Docket Item # 12
BAR CASE # 2008-0234

BAR Meeting
December 17, 2008

ISSUE: Alterations
APPLICANT: Ray Lewis for Marie Potier
LOCATION: 1314 King Street
ZONE: KR/King Street Urban Retail

Figure 6: Proposed Plan and Elevation - King Street

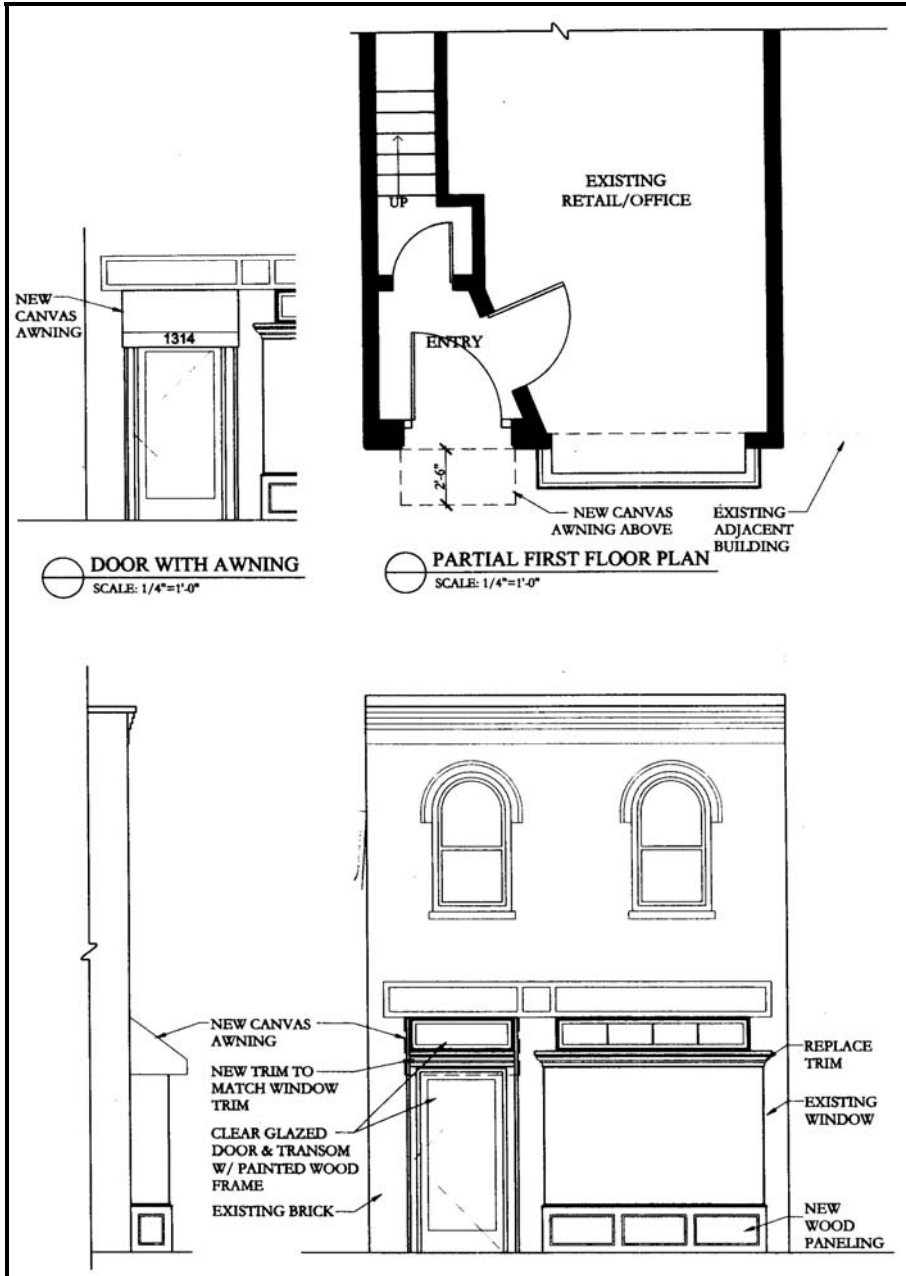
In general, Staff is supportive of the alterations proposed by the applicant. The removal of the brick veneer at the base of the bay window and the installation of the more historically appropriate wood paneling will be a significant aesthetic improvement. The proposed new door is also appropriate and will enclose a rather unusual large open vestibule. Staff’s only recommendation as it pertains to the new door is that the glass be beveled around the edges, if feasible, to more closely resemble a historic wood commercial door.

1. that the glass in the full light door be beveled around the edges, if feasible; and,
2. that a shed or sloped awning be installed over the door on the rear addition.

Figure 7: Proposed Plan and Elevation - Rear Addition

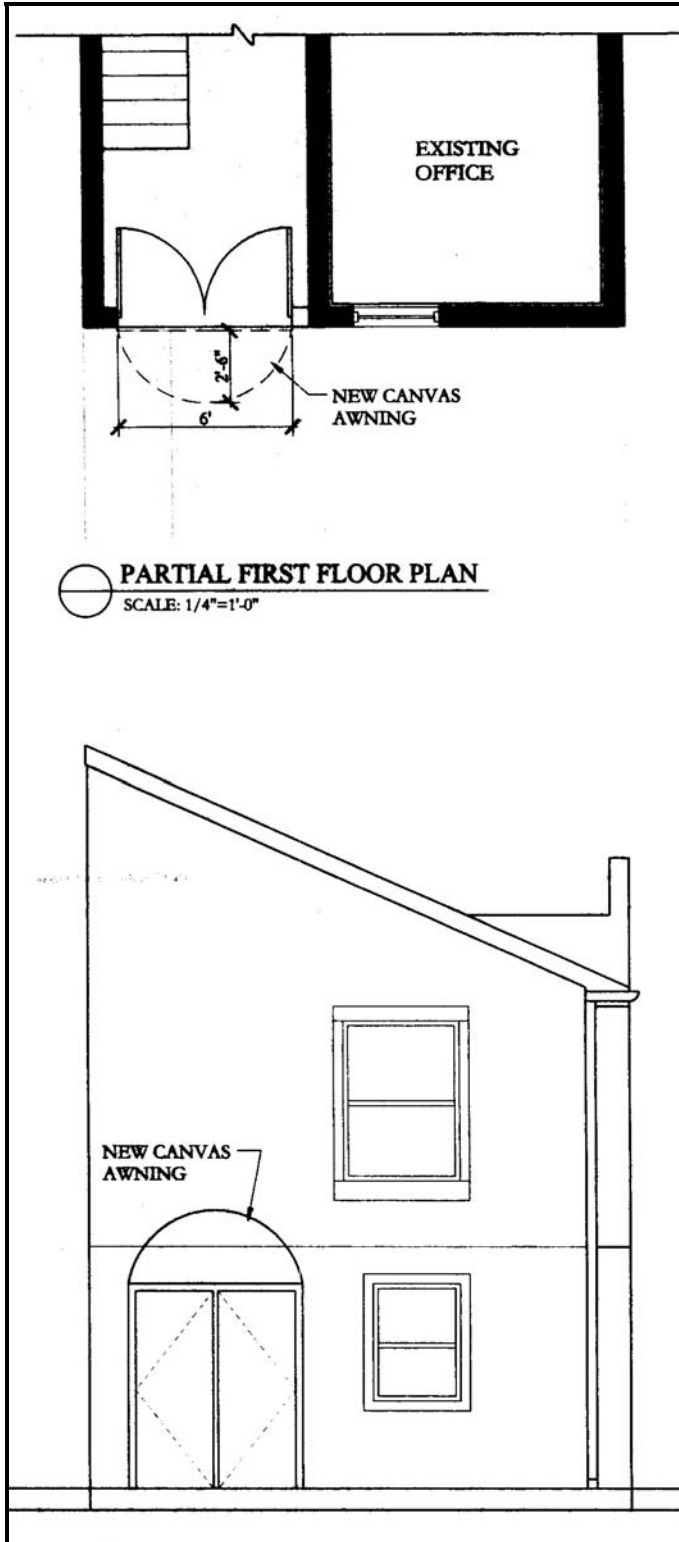
Staff also has no objection to the use of Sunbrella canvas awnings on the front and rear elevations. However, the *Design Guidelines* state that “ridged frame bullnose awnings are not appropriate on buildings which pre-date the mid-20th century.” Although the bullnose awning is proposed on the future rear addition, Staff believes a shed or sloped awning would be more in keeping with this historic, early 20th century commercial building.
